Technical BULLETIN

2007: PZ50GTW/FXW/MW/VTW MODELS

2008: PZ50GTX/RTX/MTX/VTX MODELS

Shifting Difficulties to and from Reverse

2. Confirm Shift Operation

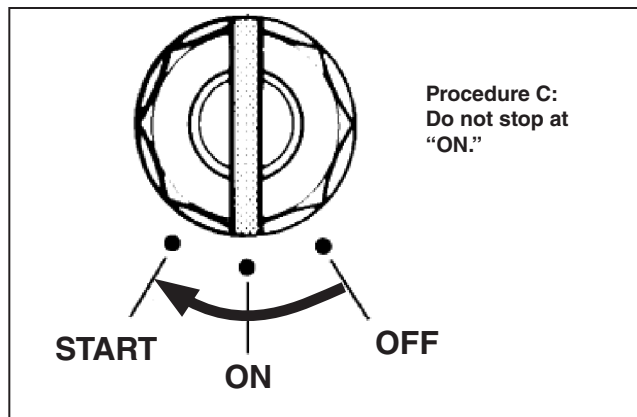
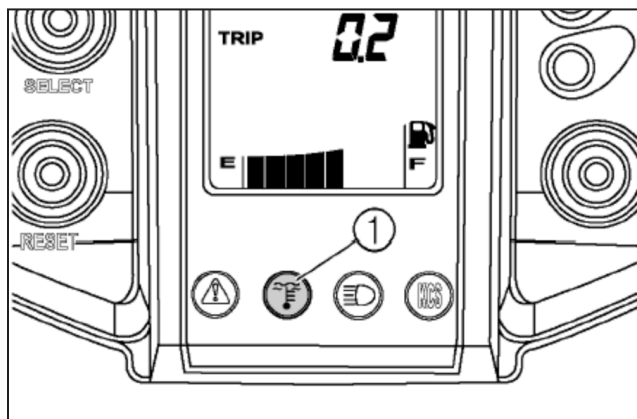
If the idle speed is correct, confirm the shifting system is operating:

- A. Remove the L/H side panel and drive belt cover and **remove the drive belt**.

- B. Lift the rear of the unit so the track is off the ground.
- C. Turn the key switch directly from OFF to START and start the engine without stopping the key at the ON position. After the engine starts, release the key to allow it to return to the ON position.

- D. While the engine is idling (with drive belt removed), press the drive select button to shift into reverse. Rotate the secondary clutch back and forth to allow the gear engagement dogs to align, and confirm that shifting has occurred.

3. Check for faulty TPS

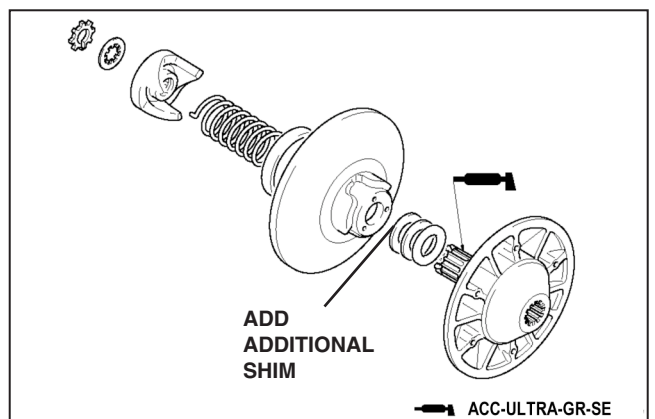
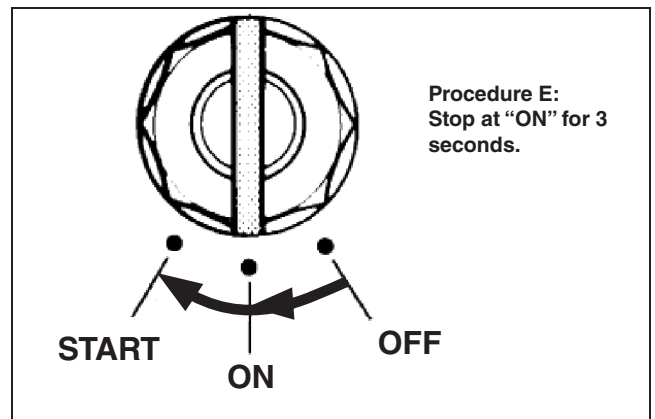
E. Turn the key switch from OFF to ON, wait for the fuel pump to cycle on and off (approx. 3 seconds), then turn the key to START and start the engine. After the engine starts, release the key to allow it to return to the ON position.

F. While the engine is idling (with drive belt removed), press the drive select button to shift into reverse. Rotate the secondary clutch back and forth to allow the gear engagement dogs to align, and confirm that shifting has occurred.

Repeat procedures E and F several times. If the unit consistently shifts to reverse using procedures C and D but will not shift to reverse consistently using steps E and F, it indicates a faulty TPS. Replace the TPS and repeat procedures to confirm.

IDENTIFICATION PROCEDURE

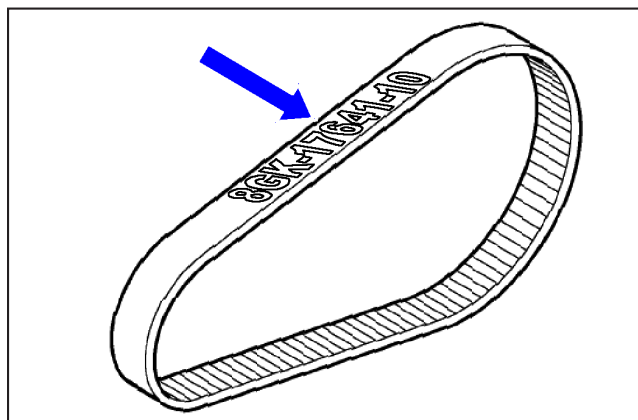
If you encounter an unfamiliar unit and you are unsure if the unit has been modified as per this bulletin, check the drive belt part number as shown in the adjacent illustration. The old belt is “-00” and the new belt is “-10.”
